INSPECTION REPORT
ARECIBO AERIAL TRAMWAY
ARECIBO, PUERTO RICO
AUGUST 6 TO 10, 2012

INSPECTION DATES: August 6 to 10, 2012

The Arecibo Aerial Tramway was inspected by Paul Jordan, P.E. of Ropeway Engineering, P.C. from August 6 to 10, 2012 in order to verify compliance with all applicable sections of ANSI Standard B77.1-1982 and to ascertain overall operating condition.

Photo 5 – Measuring track rope tension.

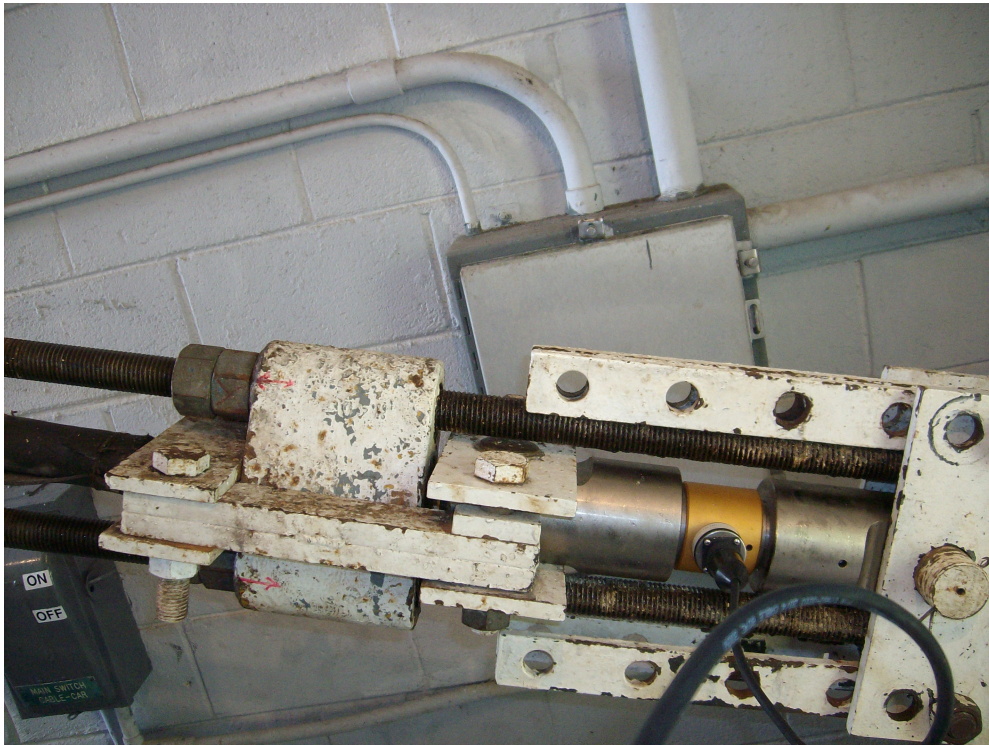
Inspected travel limit switches in lower terminal including wiring connections. Arecibo staff measured tension in the track rope at 5,700 lbs (See Photo 5) and haul rope at 535 lbs at a temperature of 90 degrees F. Tested track cable brake again by taking car to mid-span with 2 people on board and stopping the car. The track cable brake was then applied. The motor was disconnected from the electrical power source and the Sterns service brake was released manually. The car then rolled downhill due to the force of gravity. The track cable brake clamps on to the track rope but does not grip tightly enough to slowdown or hold the car. (See Photo 8.)

Photo 6 – Over speed sensing switch showing manual reset location (below microswitch).

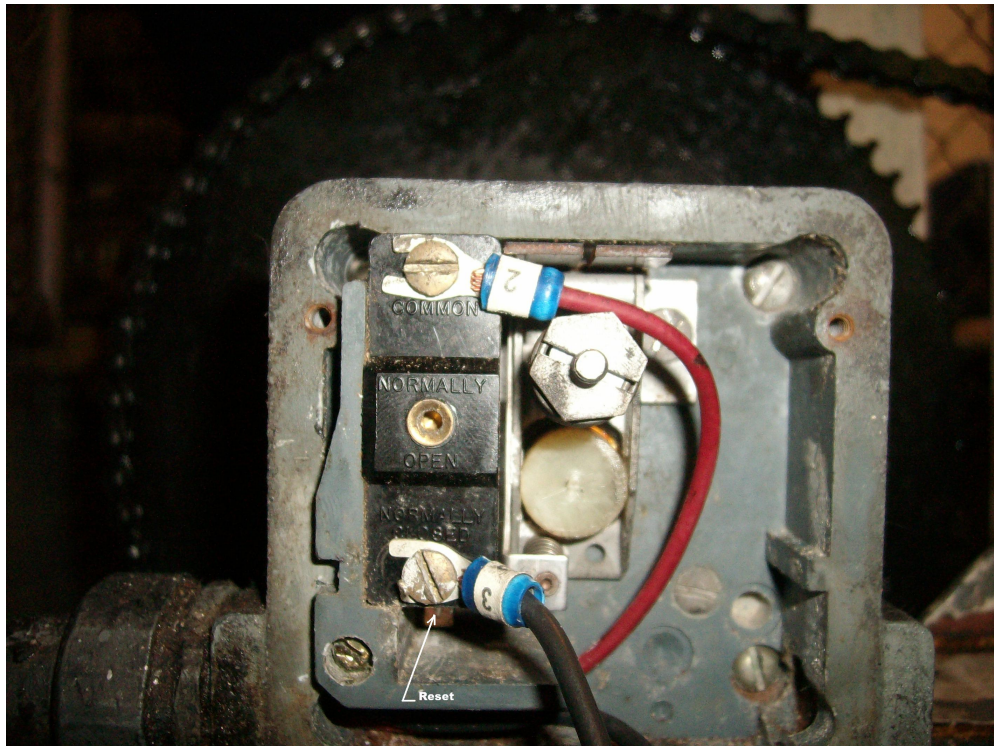
Friday, August 10 Inspected travel limit switches in upper terminal including wiring connections. Tested the over speed sensing switch by disconnecting the drive chain and turning the sprocket manually. The sensing switch opened its contact upon sensing the over speed. The switch was then reset (See Photo 6) and the drive chain was put back on the sprocket.

Photo 7 – Inspecting the Sterns service brake.

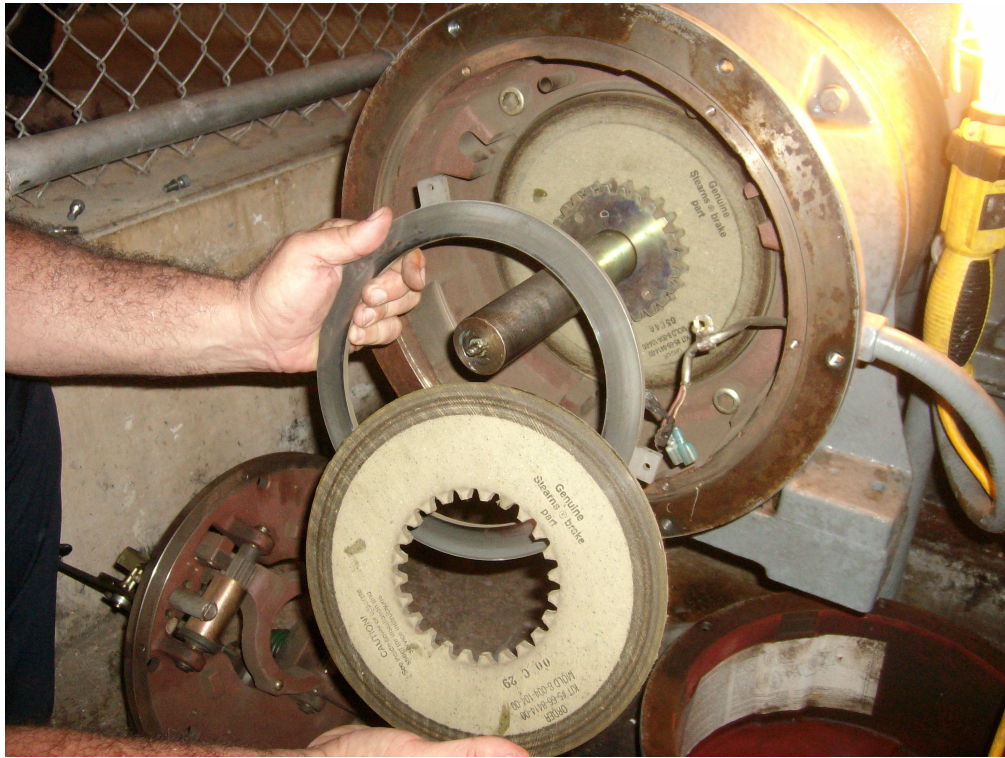
slow down in either direction and there was no slippage of the haul rope in the drive sheave. Successfully tested automatic application of the track rope brake by slacking off the haul rope at the car with a lever hoist. (See Photo 3.) Disassembled and inspected brake pads and disks of Sterns service brake. (See Photo 7.)
